Rezoning Transportation Analysis

Petition Number: 2019-072

General Location Identifier: 04507101, 04509301

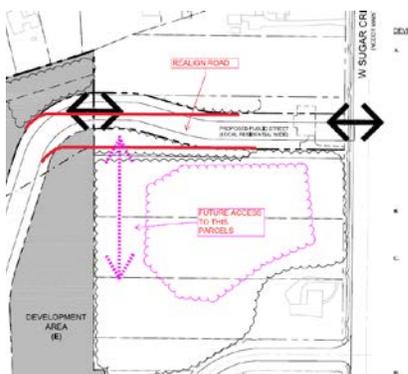
6. The petitioner should revise the site plan and conditional note(s) to realign the road extension to sugar creek so that the R/W completely abuts the property line as shown below. The realignment will provide access private/public drive to the parcels along West Sugar Creek Road, and reduce the number of driveways on Sugar Creek Road.
